### **New Albany Planning Commission Agenda**

Wednesday, January 17, 2024 7:00 p.m.

### New Albany Planning Commission DRAFT Meeting Minutes

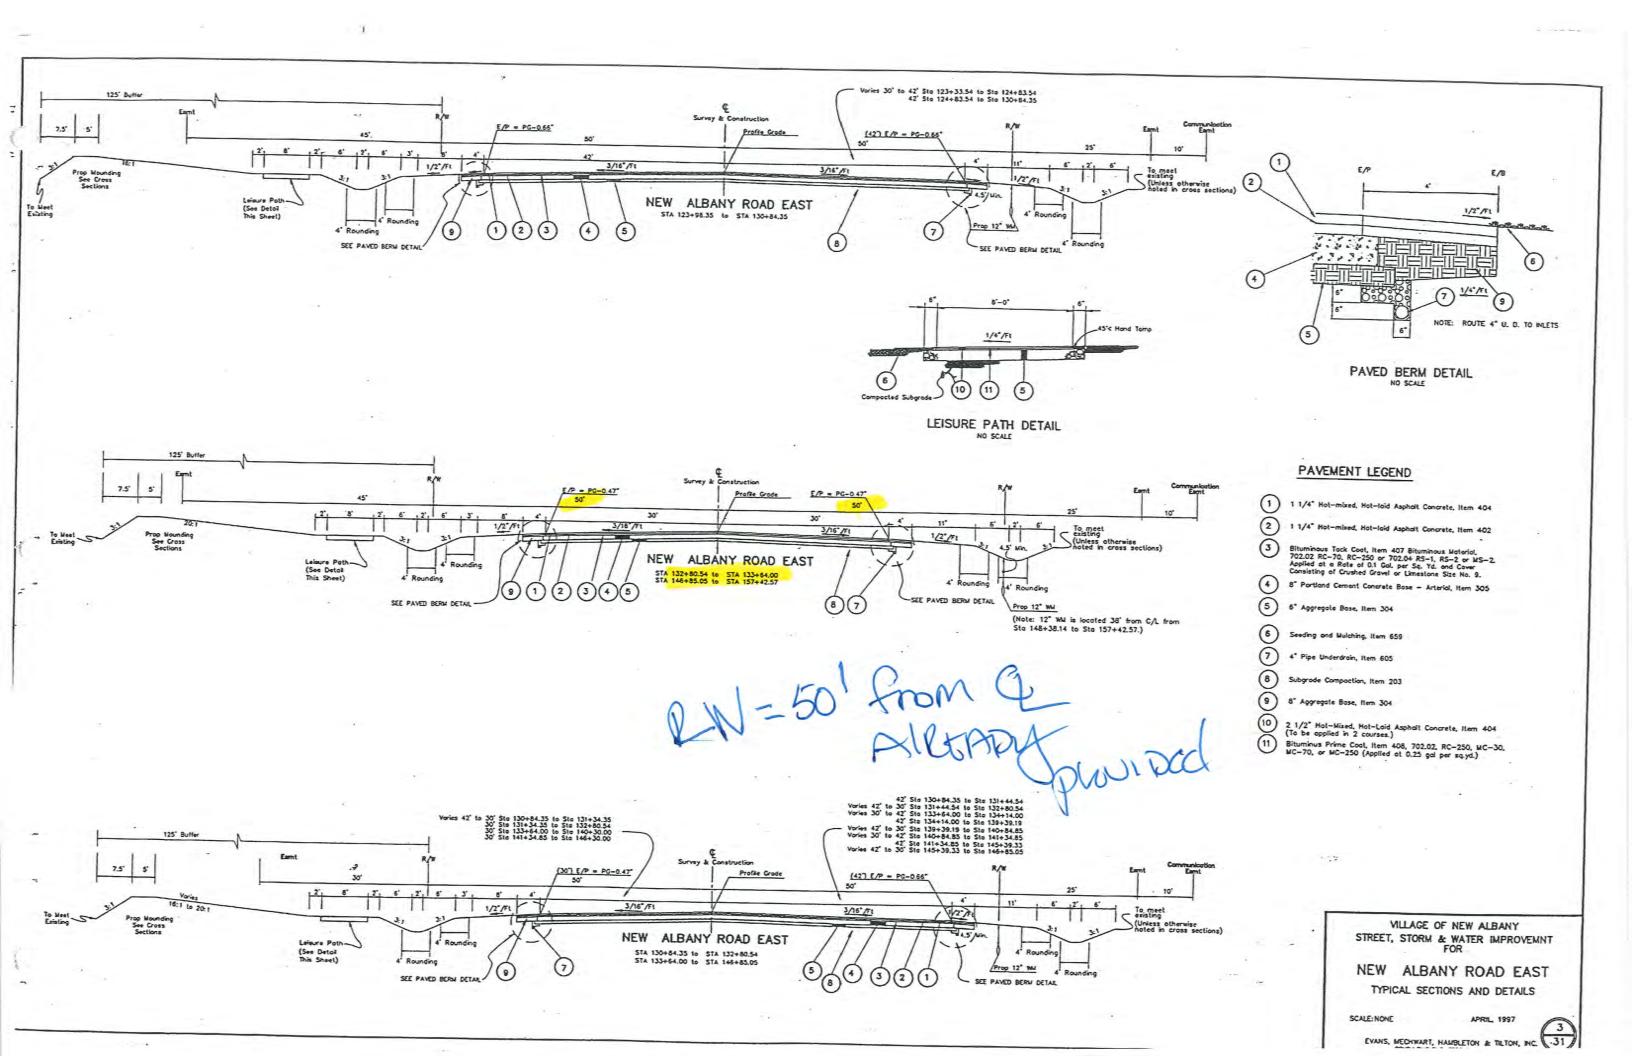
Our review comments are as follows:

1) We will require a Traffic Impact Study for review and approval once a development project is identified for this site.

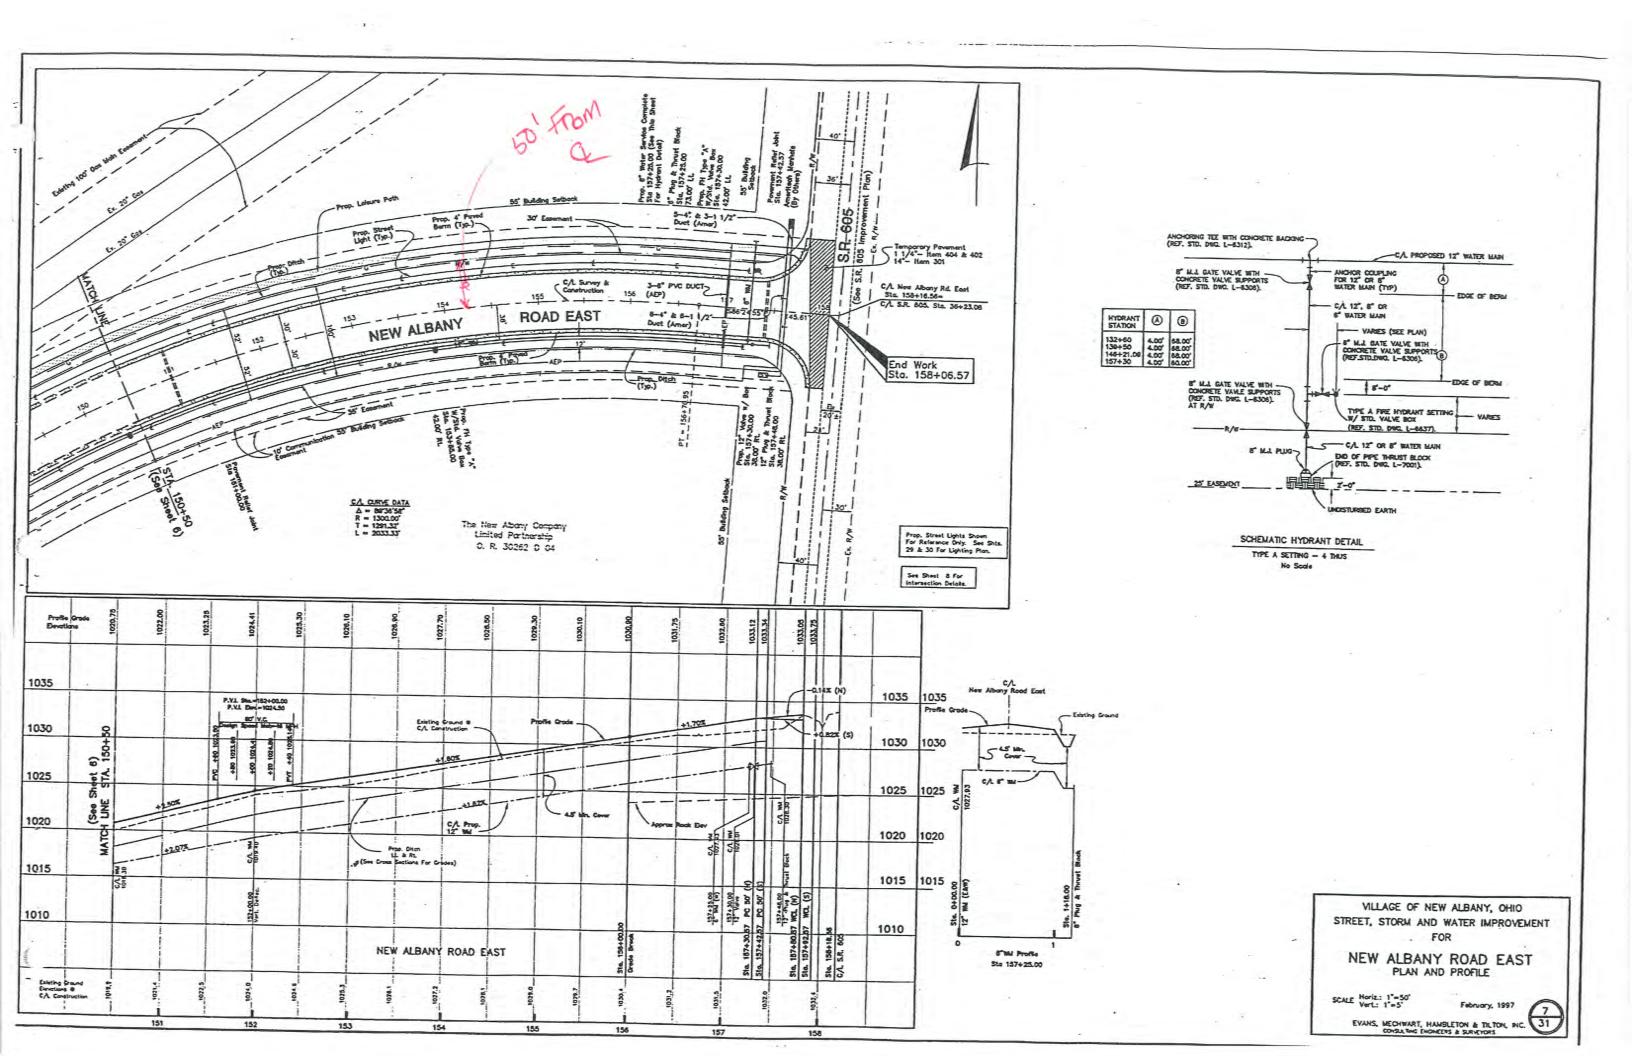
2) The rezoning text states that 50' of public r/w as measured from road centerline will be provided along NA Road East and SR 605. This condition is already met along NA Road East. An additional 10' of public r/w will need to be dedicated along SR 605 where 50' is not already provided.
